SUNDRY NOTICES AND REPORTS ON WELLS
Do not use this form for proposals to drill or to re-enter an abandoned well. Use form 3160-3 (APD) for such proposals.

8. Well Name and No.
MALLON 33 FEDERAL 04

Mallon 33 Federal #4

Permanent Abandonment of Federal Wells
Conditions of Approval (LPC Habitat)

Mallon 33 Federal #4

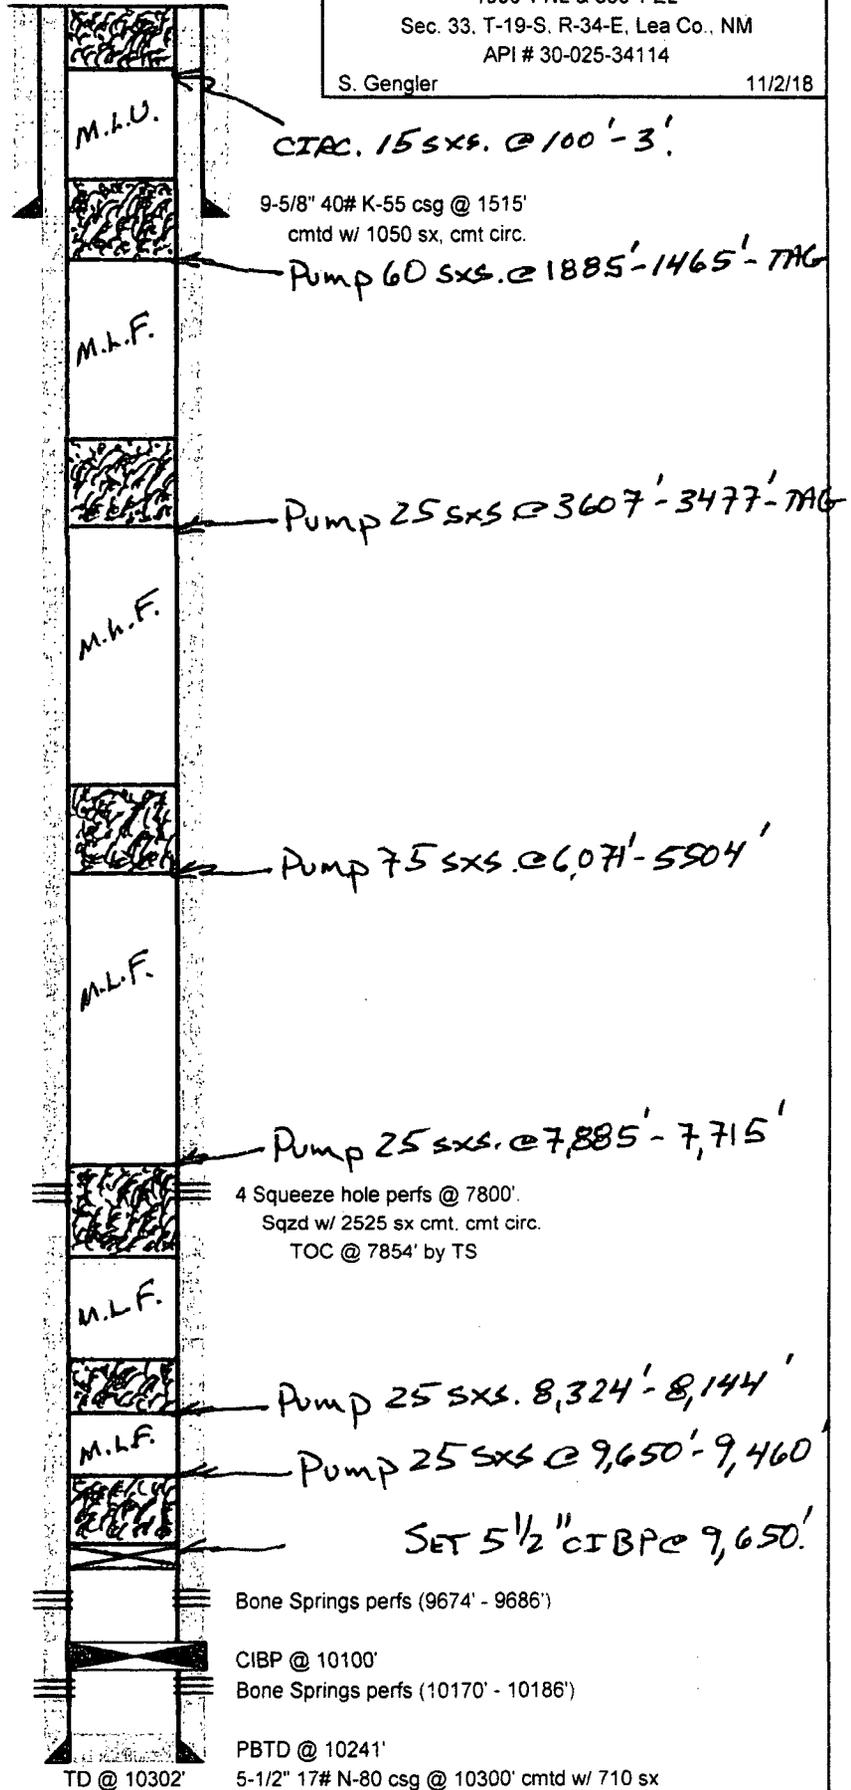
Below ground level dry hole marker required

** BLM REVISED **

SEE ATTACHED FOR
CONDITIONS OF APPROVAL
